Report Title:	Safe Drinking Water Act Compliance Inspection Report		
Regulatory Program(s):	Public Water System Supervision (PWSS)		
Inspection Date(s):	Tuesday, July 26, 2022 – Thursday, July 28, 2022		
System Name:	City of Richmond		
PWS ID:	VA4760100		
System Address:	3920 Douglasdale Road		
	Richmond, Virginia 23221		
Latitude:	37.544420	Longitude:	-77.499260
NAICS Code:	221310	SIC:	4941
Unique Project #:	3E22DW019A		
Site/Facility Representative(s):			
	Douglas Towne, Plant Operations Superintendent		☒
	Phone: 804-646-1811	Email: douglas.towne@rva.gov	
EPA Inspectors:			
	Leah Zedella		
	Phone: 215-814-2838	Email: zedella.leah@epa.gov	
	Amy Cohen		
	Phone: 215-814-3296	Email: cohen.amy@epa.gov	
	Jessica Landkrohn		
	Phone: 206-593-6437	Email: landkrohn.jessica@epa.gov	
	Kate Abazis		
	Phone: 206-638-7933	Email: abazis.kate@epa.gov	
	Stephen Fitzner		
	Phone: 541-250-1444	Email: fitzner.stephen@epa.gov	
EPA Contractors:

Photograph 45. Water and algal growth on floor of Korah 2 and 3 Pump Station.

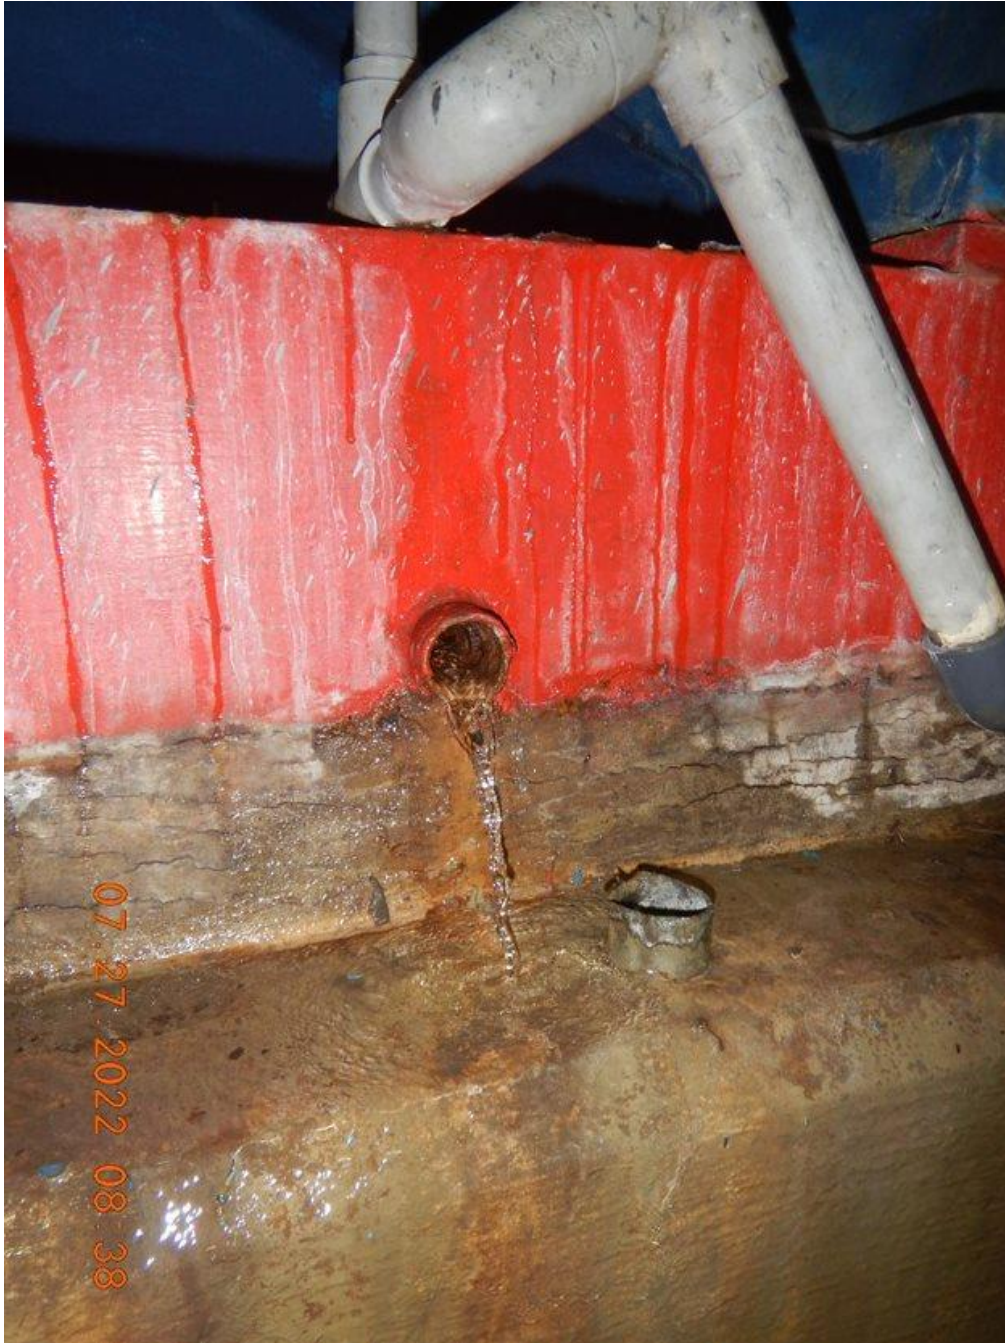
Photograph 44. Water flowing across floor near K3-2 pump, and algal growth on floor near pump motor in Korah 2 and 3 Pump Station.
